Access Compliance Report

Public Rights-of-Way

Intersection ID: 16483	Main Street: QUEENS_RD	Cross Street: RADCLIFFE_AV	Location: SE
ADA ID: 137B0DB306CC	Ramp Type: MedianPerp	Initial Pass/Fail: Fail	Overall Compliance: No
Severity Score: 10			
Codes/Mitigation Info/Possible Solution		Field Measurements/Component Compliance

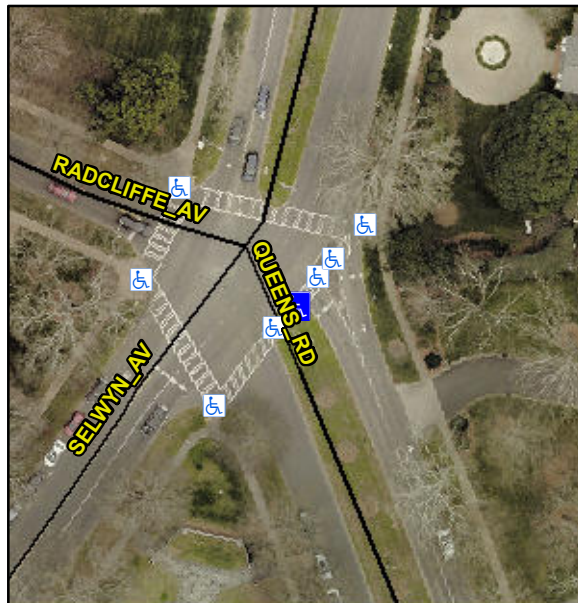
Not Found, R304.5.1, R304.5.3

Compliance	Description	Data	Compliance	Description	Data
N/A	Ramp Length (in)	79.0	Yes	Ramp Slope (%)	6.1
No	Ramp Width (in)	45.0	No	Ramp XSlope (%)	2.6
N/A	Flare Type LT	N/A	N/A	Flare Type RT	N/A
N/A	Flare Slope LT (%)	N/A	N/A	Flare Slope RT (%)	N/A
N/A	Flare Traversable LT?	N/A	N/A	Flare Traversable RT?	N/A
N/A	Landing Length (in)	N/A	N/A	DWS Provided?	N/A
N/A	Landing Width (in)	N/A	N/A	DWS Contrast?	N/A
N/A	Landing Slope (%)	N/A	N/A	DWS Length (in)	N/A
N/A	Landing X Slope (%)	N/A	N/A	DWS Full Width?	N/A
N/A	Landing Curb? (Y/N)	N/A	N/A	DWS Offset (in)	N/A
N/A	Shared Landing?	N/A			
N/A	Gutter Ponding?	N/A	N/A	Gutter Slope (%)	N/A
N/A	Gutter Lip Ht (in)	N/A	N/A	Gutter X Slope (%)	N/A
N/A	Painted X Walk1?	Yes	N/A	Painted X Walk2?	N/A
	X Walk 1 Direction	To NE		X Walk 2 Direction	N/A
N/A	X Walk 1 Width (in)	77.0	N/A	X Walk 2 Width (in)	N/A
	X Walk 1 Slope (%)	0.0		X Walk 2 Slope (%)	N/A
	X Walk 1 X Slope (%)	2.4		X Walk 2 X Slope (%)	N/A

Remove & Replace Entire Ramp.
